Our Ref: 26700-342-01
Council Ref: MCU24/0117
& RAL24/0075
QA: es

RESPONSE TO INFORMATION REQUEST – MCU24/0117 & RAL24/0075

Development Permit for Reconfiguring a Lot (Two Lots into Five Lots, New Road and Easements) combined with Material Change of Use (Child Care Centre, Service Station, Car Wash, Low Impact Industry and Food & Drink Outlets)
182 Shaw Road, Shaw

Figure 1 – Dalrymple Road / Bishop Putney Avenue signalised intersection

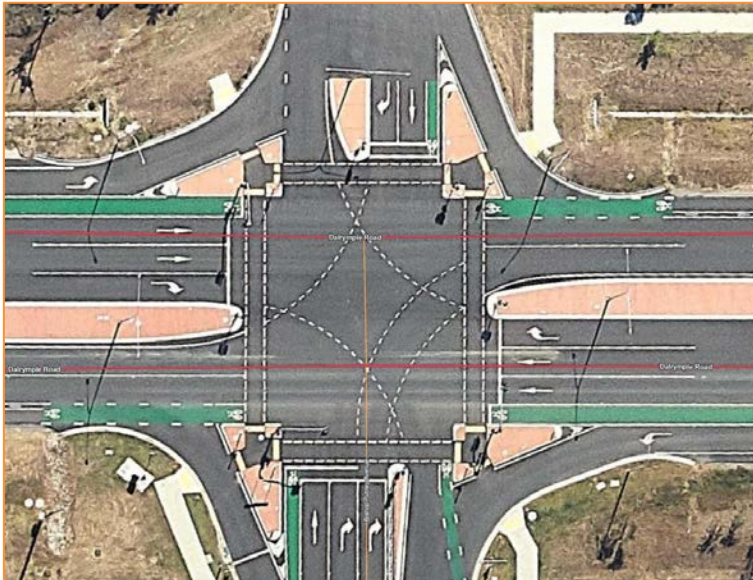
The pedestrian footpaths along Shaw Road and Dalrymple Road are not planned to connect to the Shaw Road/ Dalrymple Road signalised intersection as this intersection does not incorporate pedestrian signals for safe crossing.

Pedestrians are to be encouraged to utilise the existing pathway along Dalrymple Road which connects to the Bishop Putney Avenue/ Dalrymple Road signalised intersection. This intersection has been designed and constructed for safe pedestrian crossing. Figure 1 below demonstrates.

Figure 2 – Greater Ascot District Centre Master Plan - Work in progress

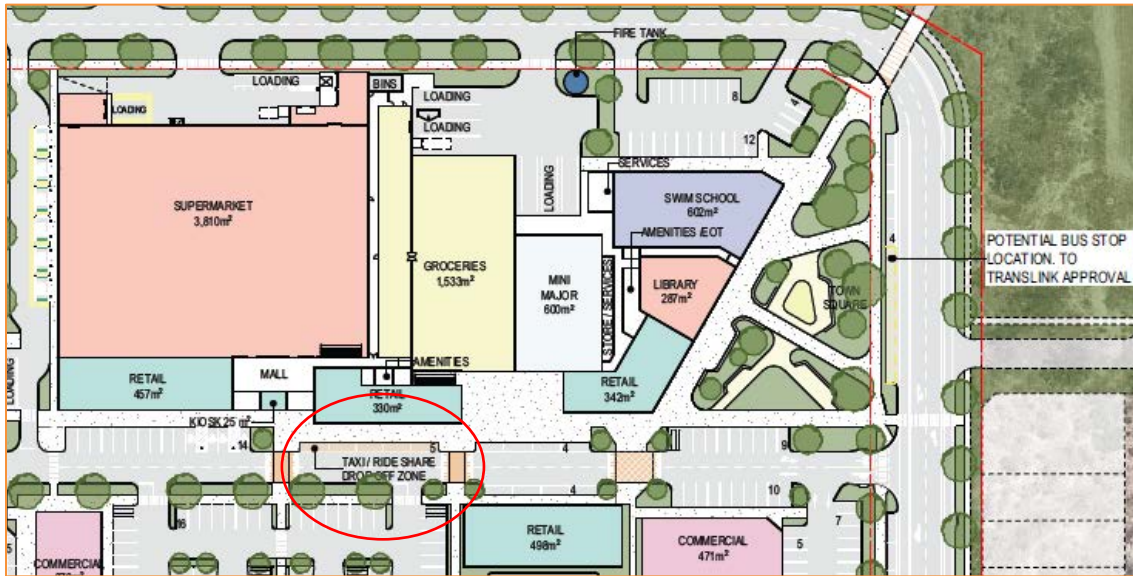
A taxi drop off/pick off zone is planned to be delivered to the front of the Supermarket as part of a later Stage for the District Centre. Figure 2 below is an extract of the Greater Ascot District Centre Master Plan which is a work in progress. The taxi drop off/pick off zone is circled in red.

DRAWING TITLE
STAGE 1 SITE PLAN

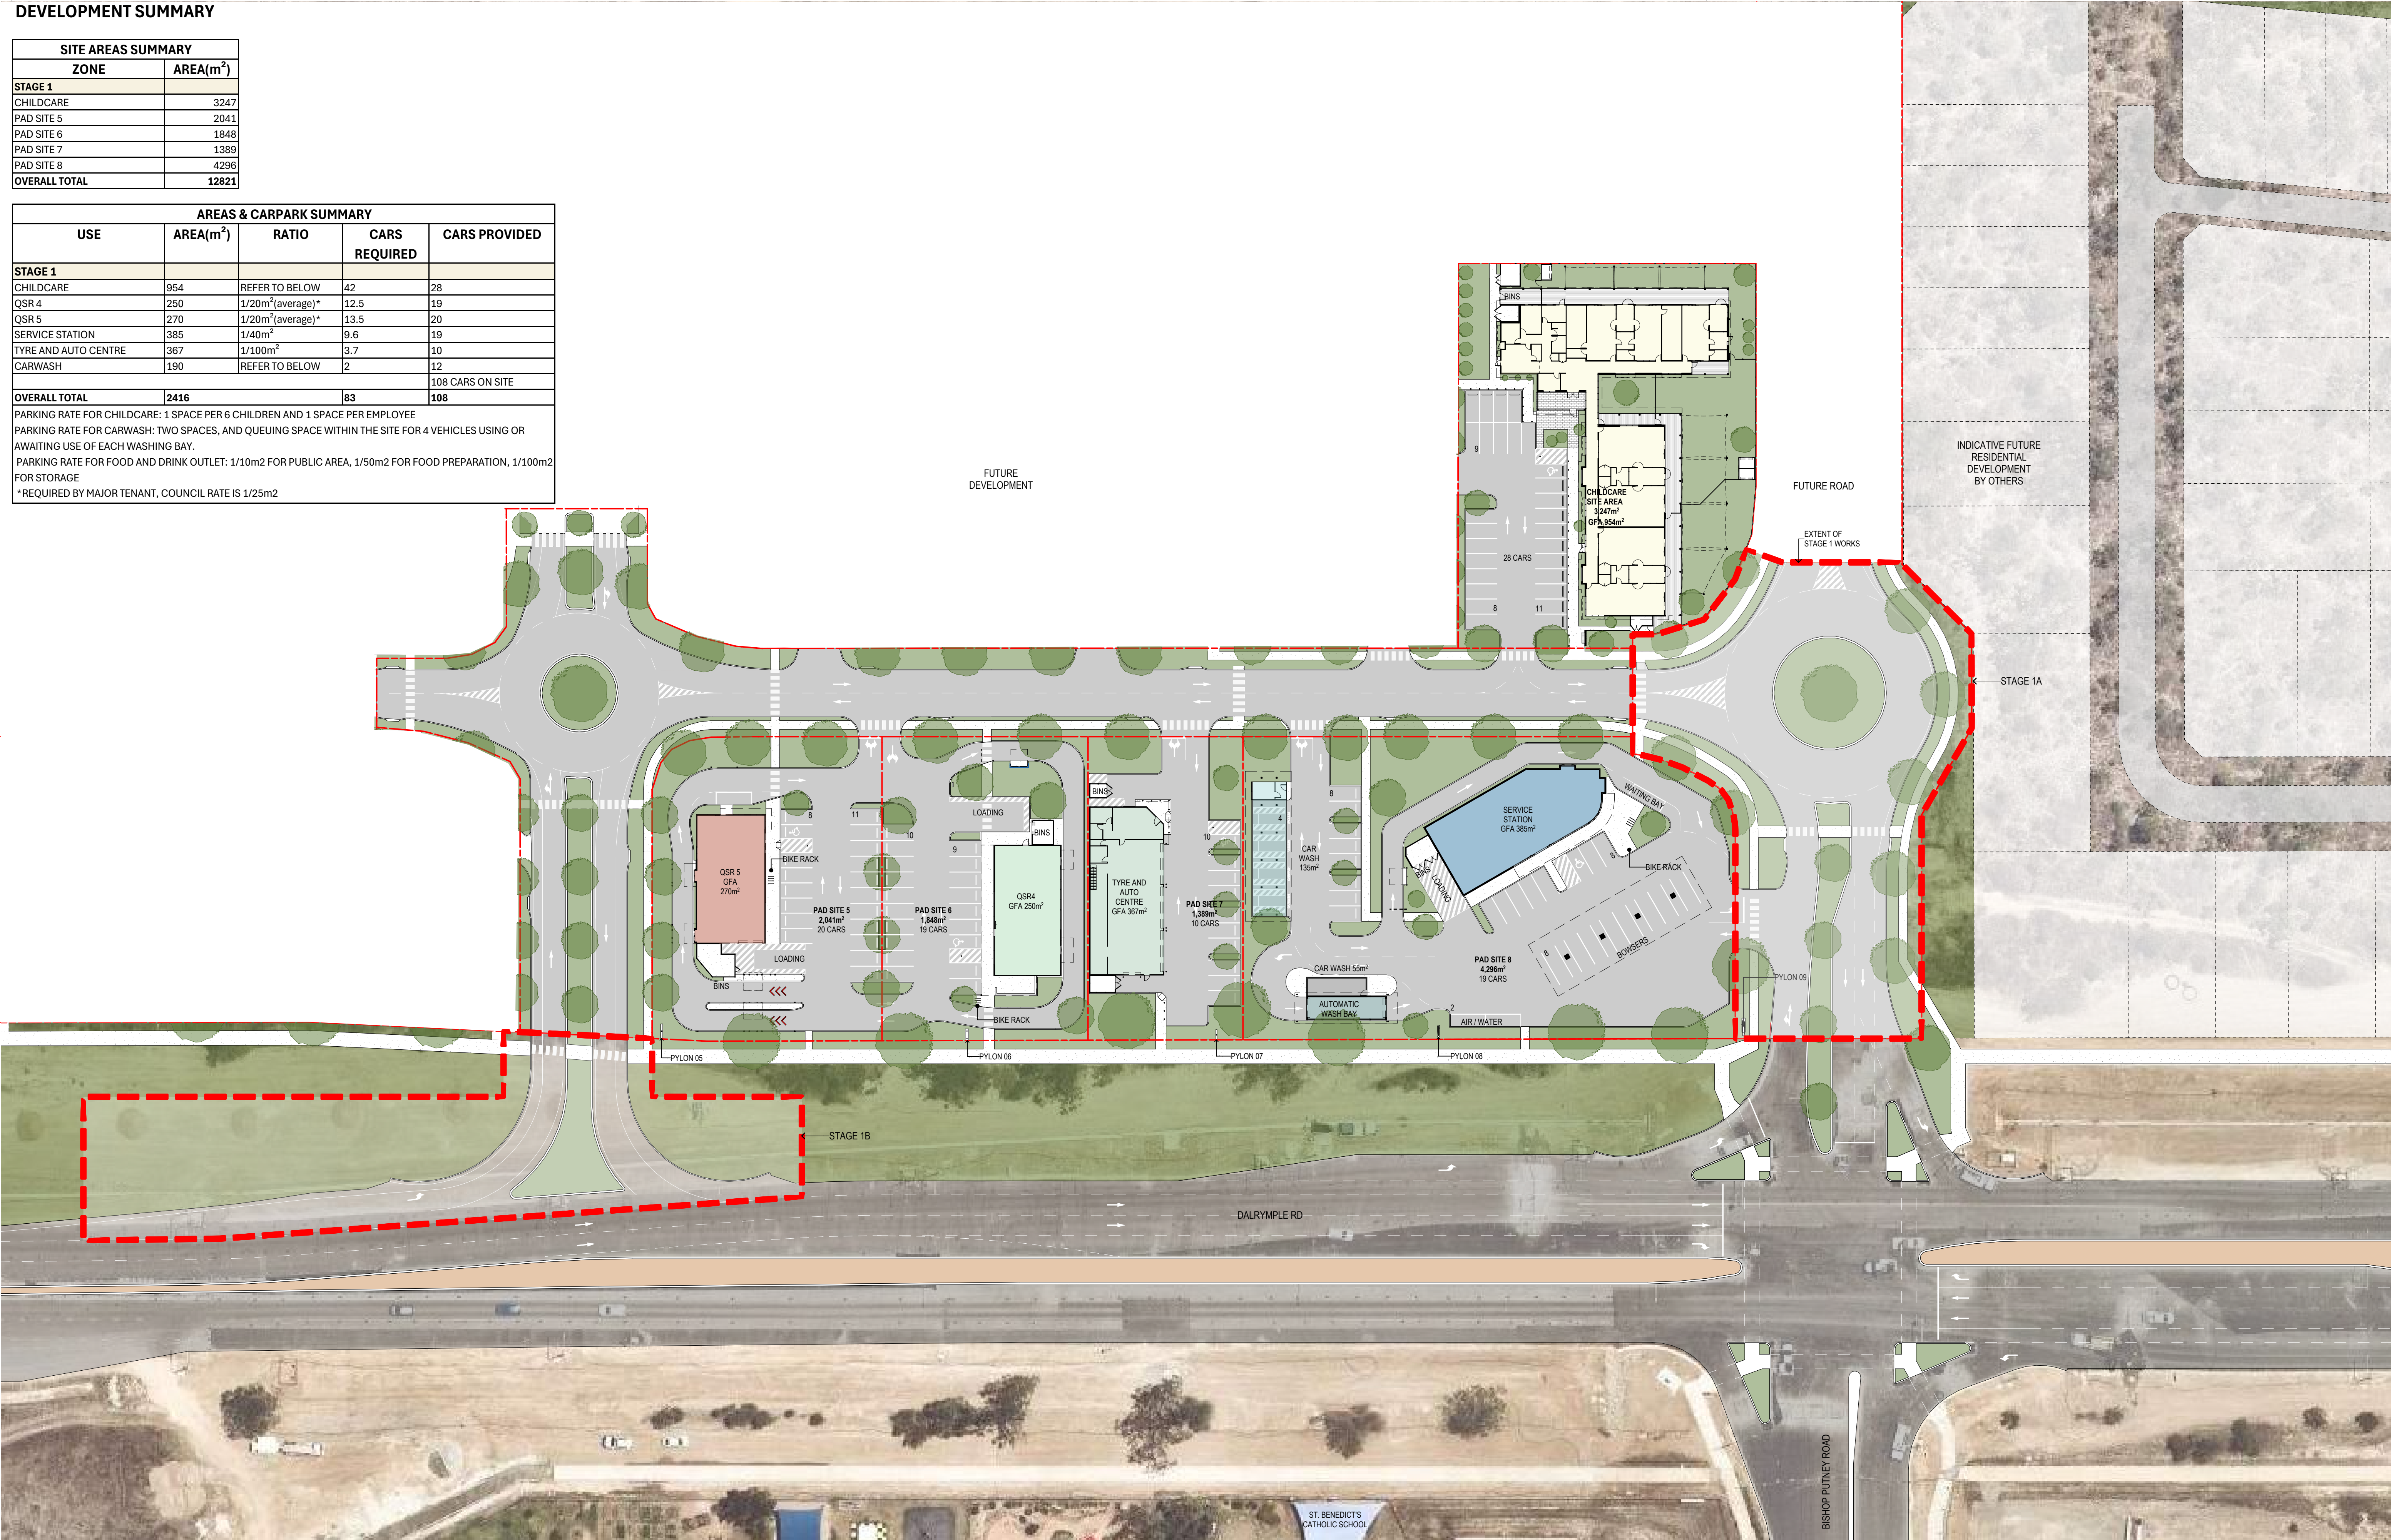
Throughout the preparation of this response to the Information Request, minor amendments to the development plans were required. This includes a change to the footprint and design of QSR 4 and the inclusion of staging the delivery of the public road. The proposed staging is demonstrated on the Stage 1 Site Plan (Ref SD1002 Rev 16). It includes Stage 1A and Stage 1B.

DIAGRAM ALL STAGE PEDESTRIAN MOVEMENT

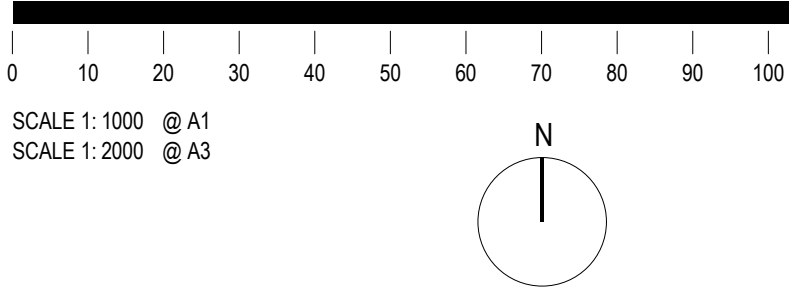
A set of amended development plans, prepared by Cottey Parker, are included in **Appendix A**. The set includes two new plans which demonstrate a conceptual active transport master plan for the Greater Ascot District Centre. Refer Drawing No SD2805 for Pedestrian Movement and Drawing No. SD2807 for Bicycle Circulation. The plans consider:

For Stage 1, residents of Greater Ascot will be able to walk to the Child Care Centre via the existing footpath in Greater Ascot Avenue and in Dalrymple Road. Additional pedestrian connections to the balance of the Estate are to be provided with later stages of District Centre as shown on the conceptual pedestrian movement plan, prepared by Cottee Parker (Drawing No. SD2805 Rev 02) in **Appendix A**.

DRAWING TITLE
SERVICE STATION FLOOR PLAN

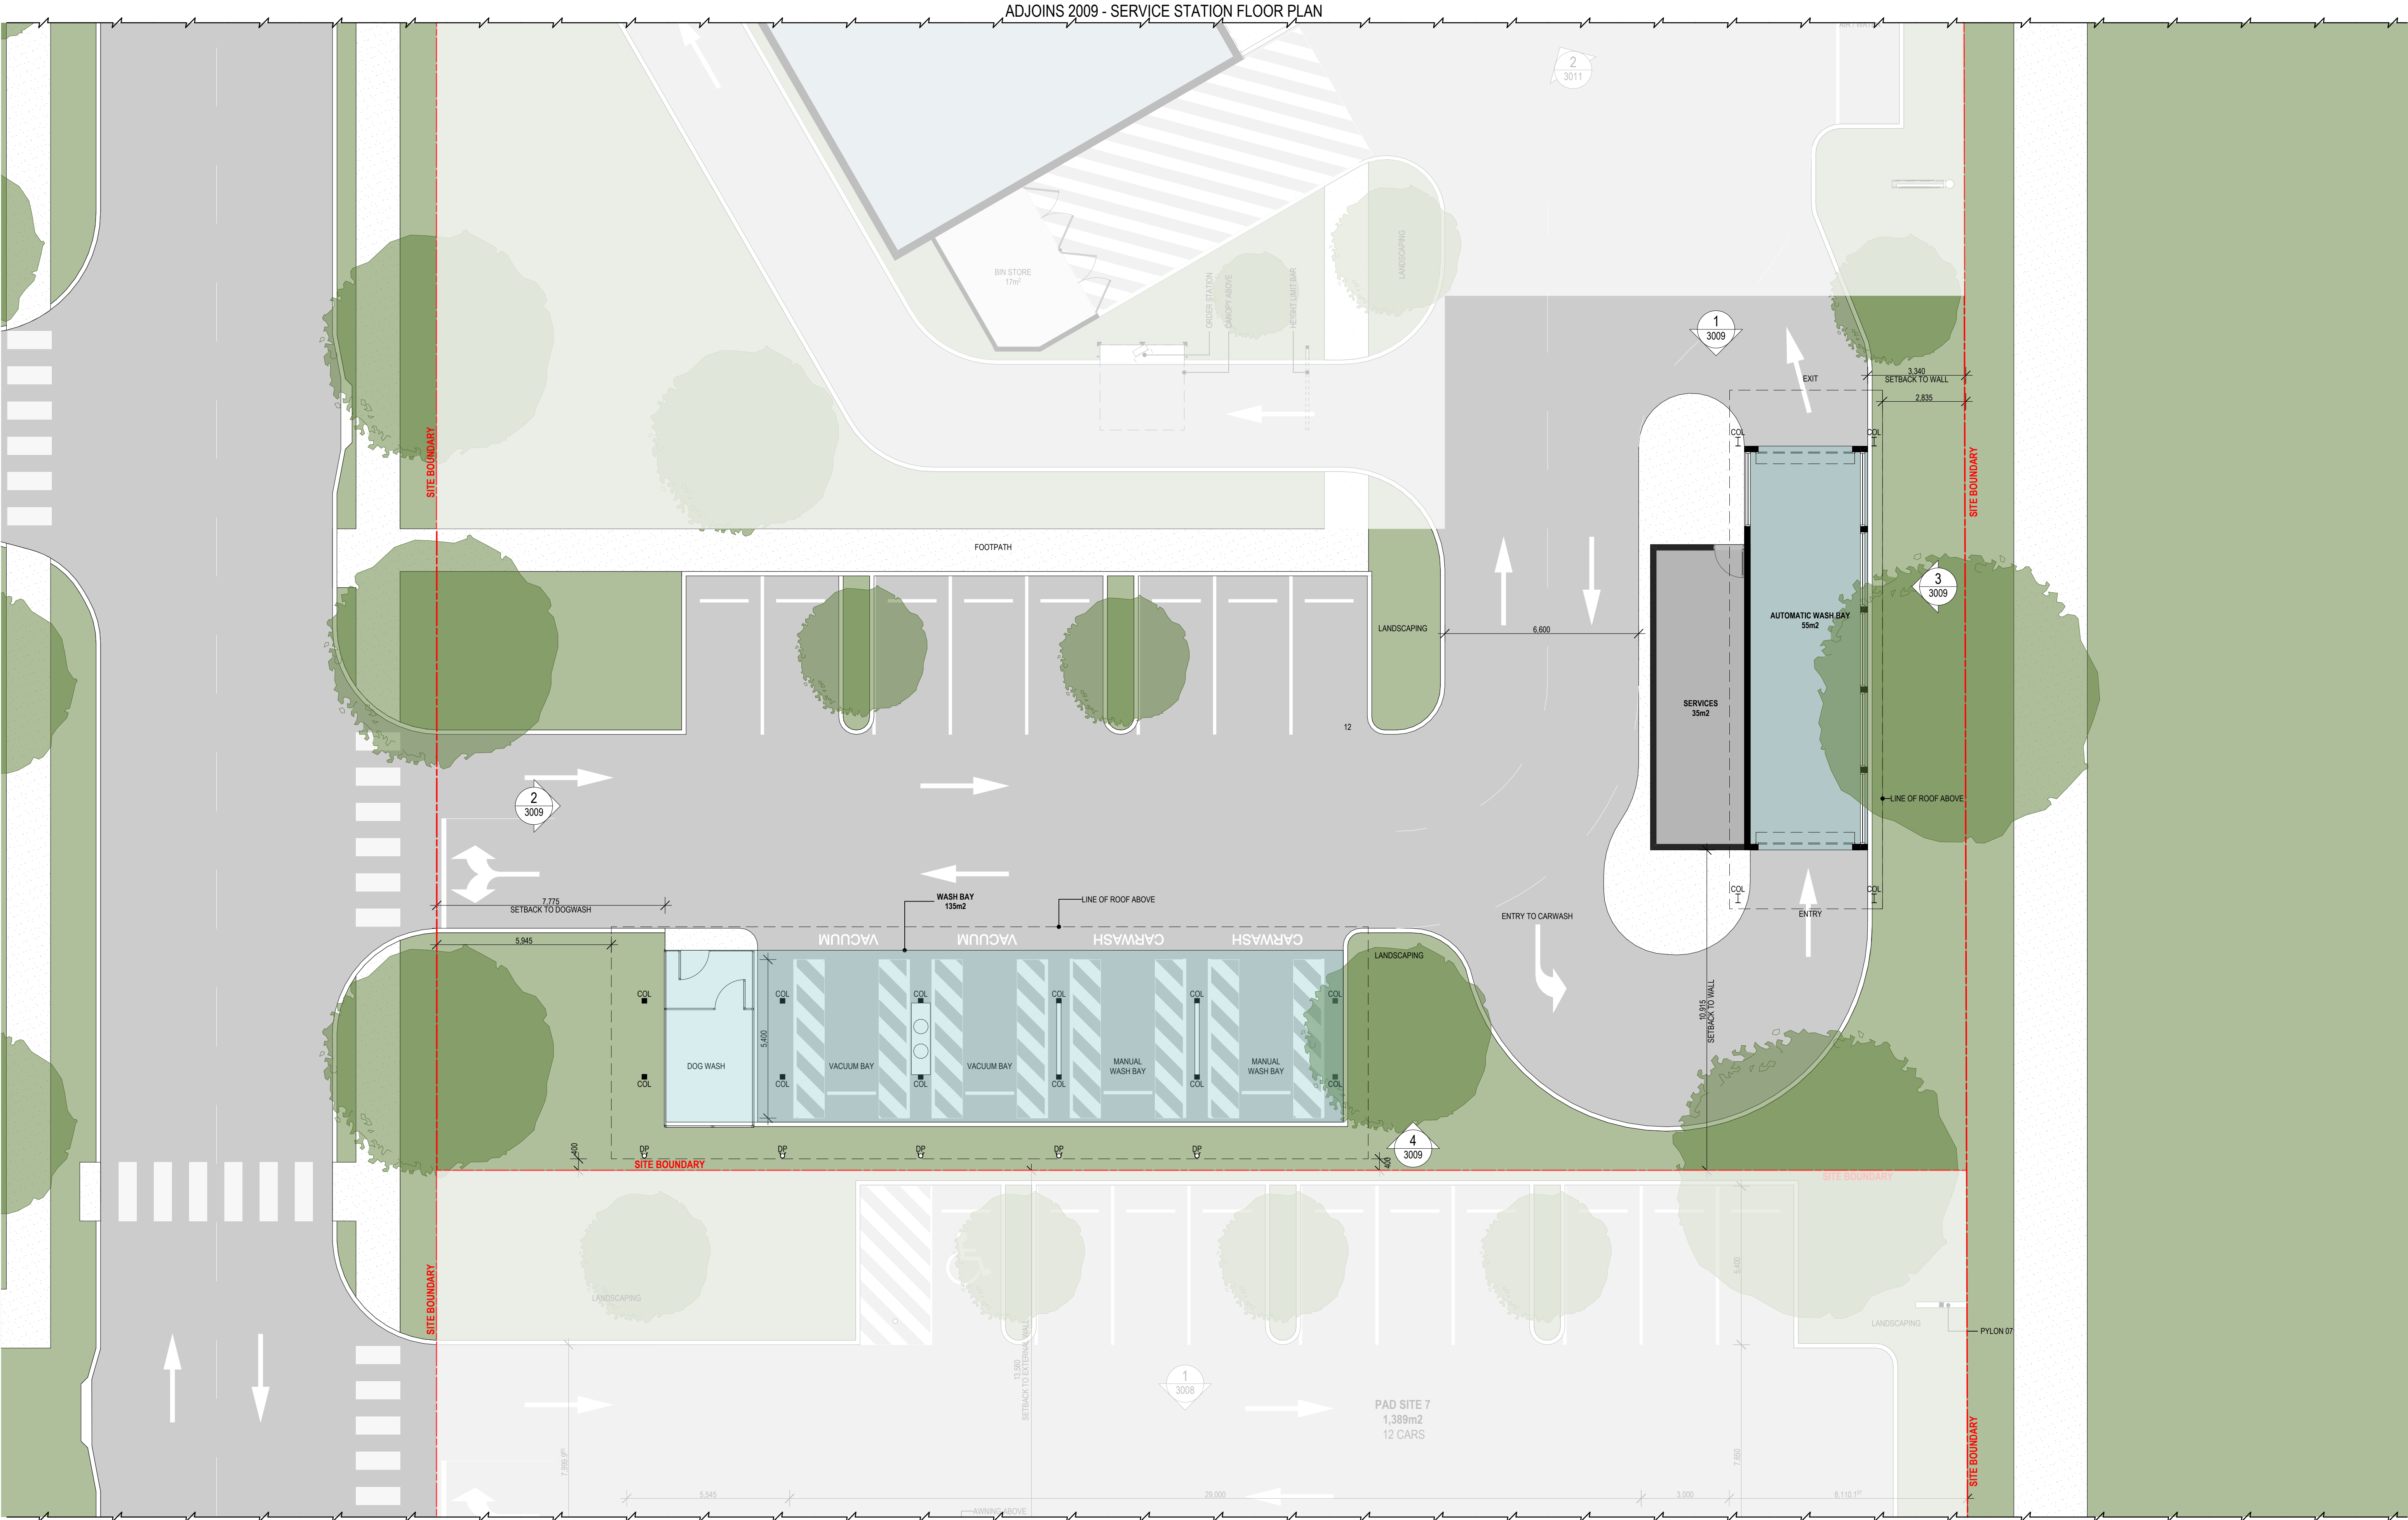
- Service station – a 17m² bin store is located on the western side of the main building. It has double gates for easy accessibility. Ample loading space is provided to the front of the bin store allowing a refuse collection truck to reverse in at the designated space and exit site in forward direction. Collection of waste will be carried out by a private collection company, as required.

The amended development plans in **Appendix A** incorporate bicycle parking provision at both Quick Service Retail Sites (Drawing Nos. SD2003 Rev 06 and SD2004 Rev 06) as well as the Service Station (Drawing No. SD2009 Rev 04) in accordance with AS 2890.3.
